DETAILED ACTION

Claims 43-54 and 56-77 are pending as amended 12/23/09 in the RCE of 6/9/09, of which 56-71 and 73 are withdrawn from consideration as non-elected invention.

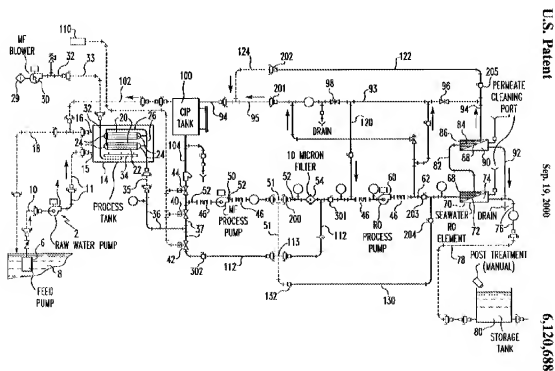
Daly teaches a reverse osmosis system with prefilter (20), reverse osmosis membranes (70,84), process tank, pumps, several solenoid valves, recirculation of the retentate water (through lines 93-93-120), back pressure regulator (see drain line or the recirculation line to the CIP tank: reverse osmosis systems require a back-pressure regulator to maintain the high pressure over the membrane for the separation to happen, and it is implied in the system if not explicitly stated). See the figure reproduced below.
